WHITEMARSH TOWNSHIP PLANNING COMMISSION

MEETING OF AUGUST 11, 2020 6:00 PM

The agenda item is SLD #02-19, Preliminary Land Development Plans for Argos Associates/Adelphi Land Associates/Polergodom Group, Ltd. for 'Longfield Farm', for development of 58 townhomes on the site, within the VC-4, Village Commercial District, Sub-district 4. You will also recall that in addition to the 58 townhomes, there is an existing pre-1940's single-family home, fronting on Butler Pike, which is being preserved as part of the development. The approximate 15-acre site is located adjacent to the intersection of Butler and Skippack Pikes. This is a continuation of the Planning Commission's review of this project; it was last in front of the Commission on June 23rd, at which time there were a number of issues the applicant was asked to address. You will recall that a conditional use for the townhomes was approved by the Board of Supervisors on November 21, 2019 with eleven conditions. [The Conditional Use Decision was one of the items in the June 23rd meeting packet and is again included for reference. Other material from that packet is not included for this meeting but is still available on the websi

SHEET: 7 OF 30

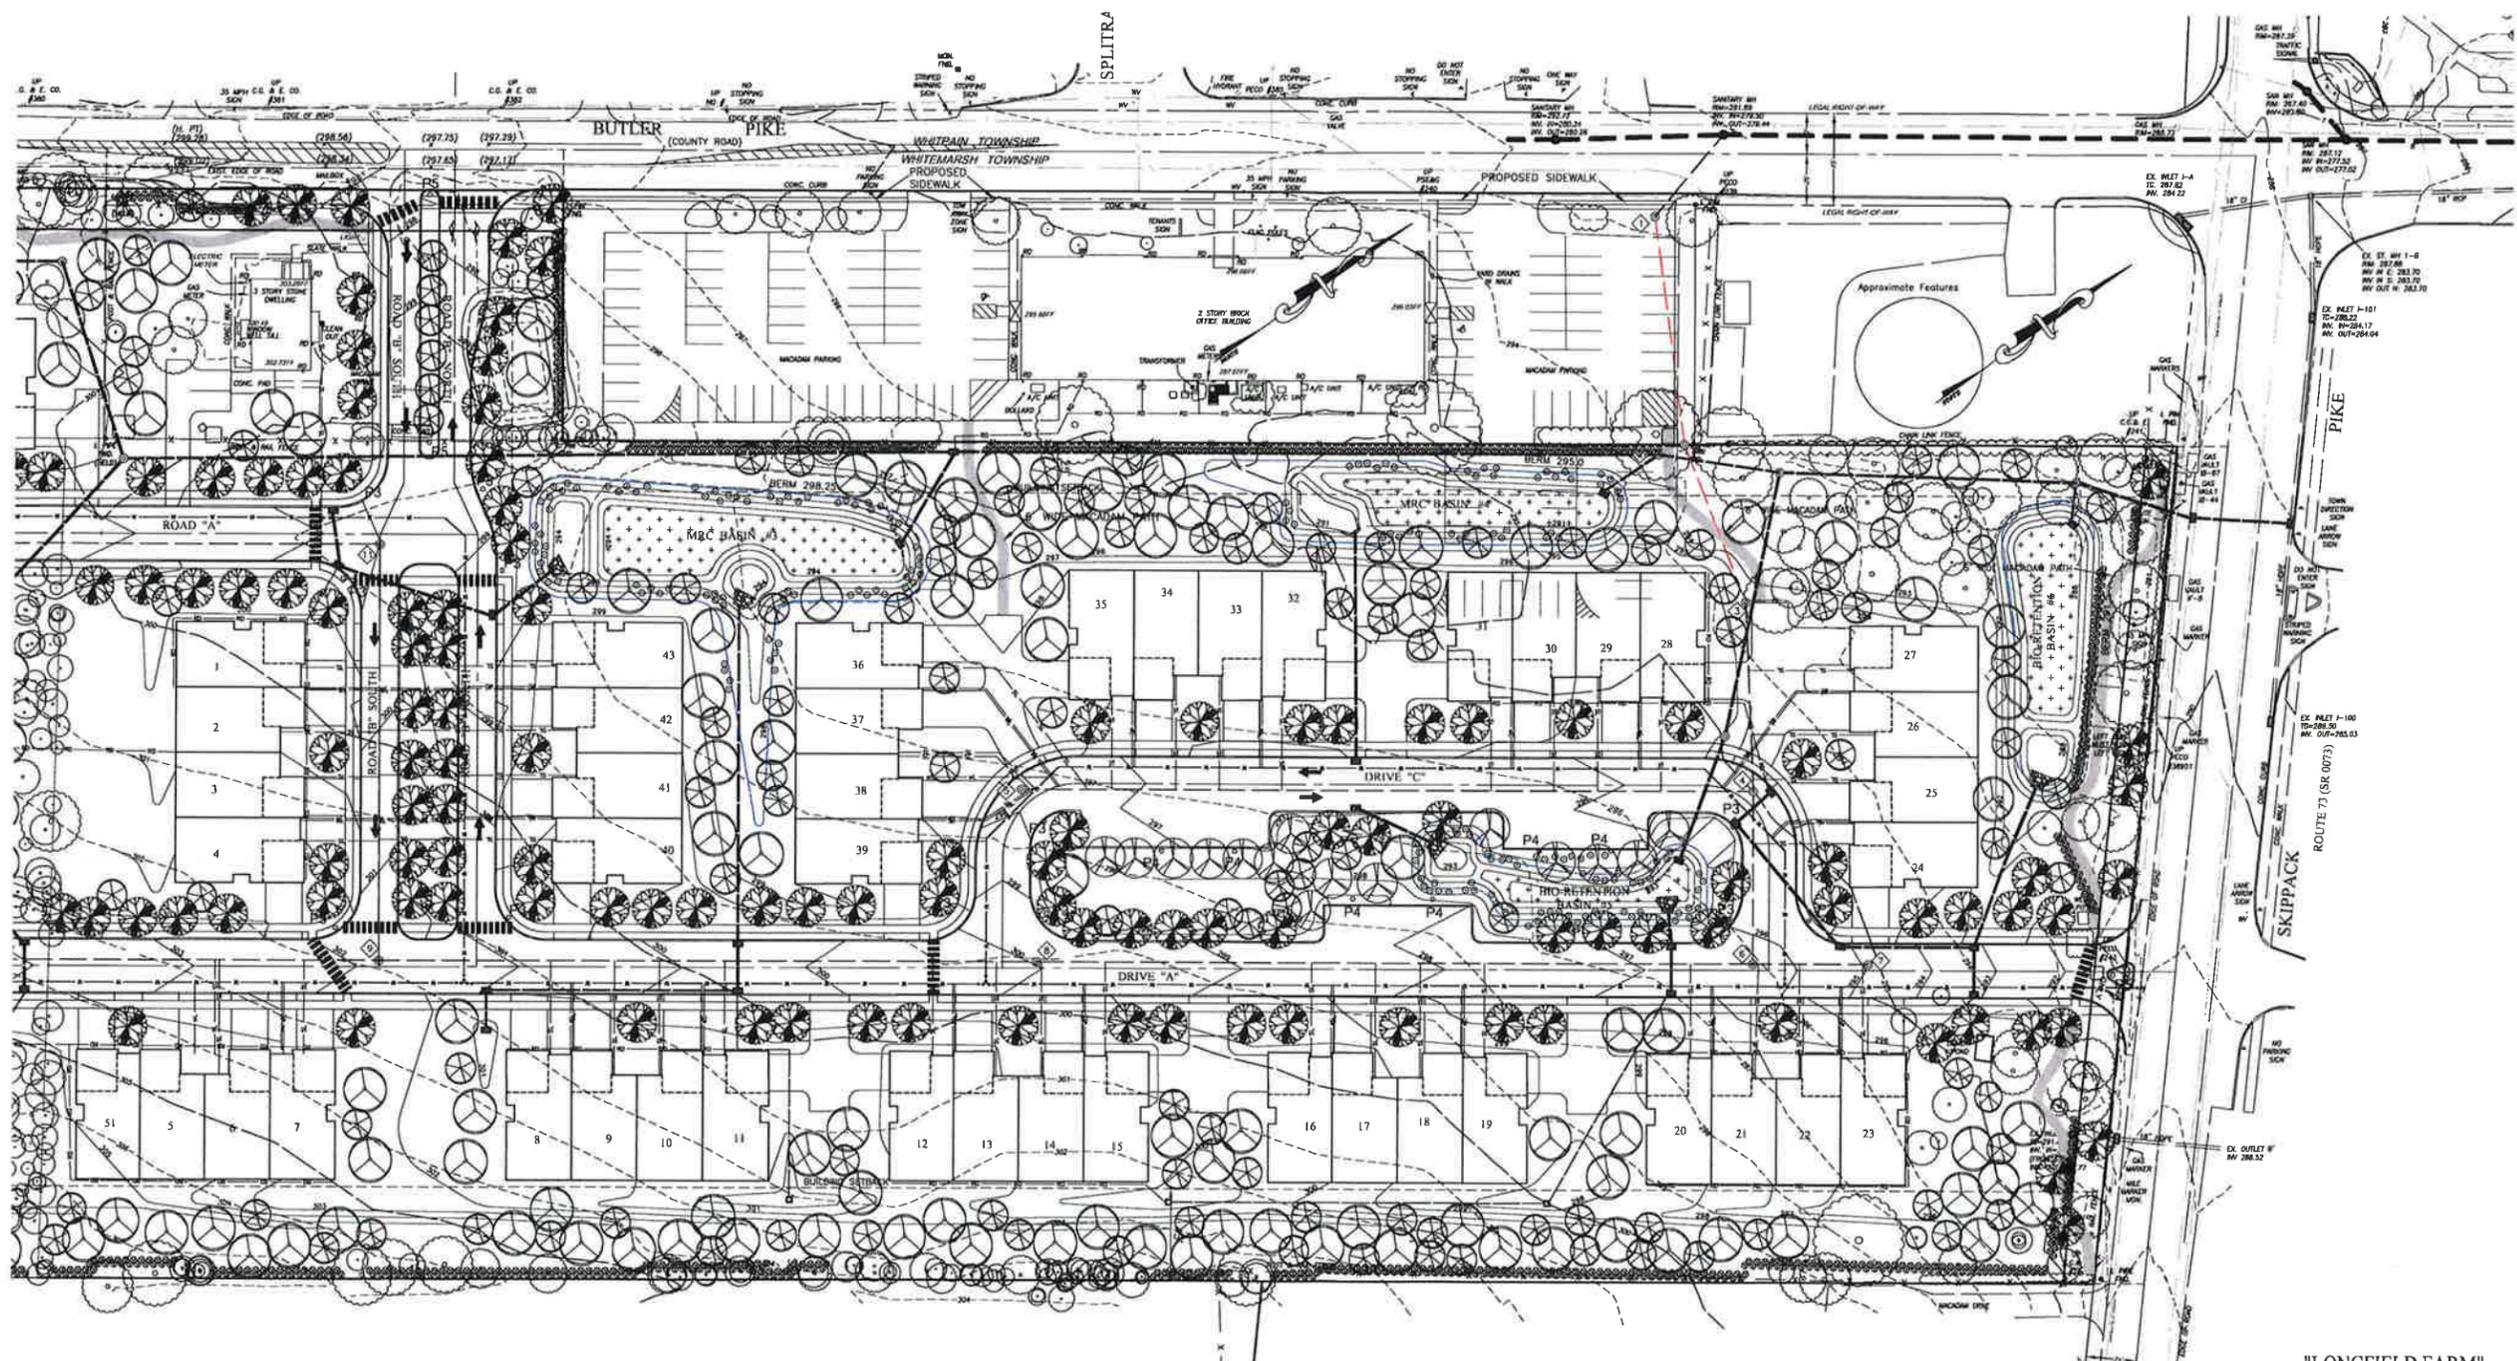
"To accept the plans as submitted but with the addition of twenty (20) canopy trees, which must be a native species, planted throughout the site assuming these changes do not impact the applicant's conditional use status."

The second part included with this submission is a revised Landscape Plan (Sheet 7 and 8 of 30, revised 7/23/20) with updated numbers on all of the required landscape components – street trees per SALDO Section 105-48(B), parking lot trees per SALDO Section 105-39(A), basin landscaping, and tree replacement per Chapter 55. Buffers (Class B, Option 5) per Zoning Section 116-291C are provided to the extent required. The code requirements for all landscape categories are met, including the full complement of replacement trees. Further, the replacement trees utilize the provisions of allowing understory trees, shrubs and perennials at the approved ratios per the SALDO.

REVISION DATE	DESCRIPTION
MARCH 27, 2020	REVISE LAYOUT TO ADDRESS CONDITIONAL USE APPROVAL
JULY 21, 2020	REVISE TO ADDRESS CONCERNS RAISED BY TOWNSHIP ENGINEER LETTER (6/19/20)
JULY 23, 2020	PROVIDE ORNAMENTAL REPLACEMENT
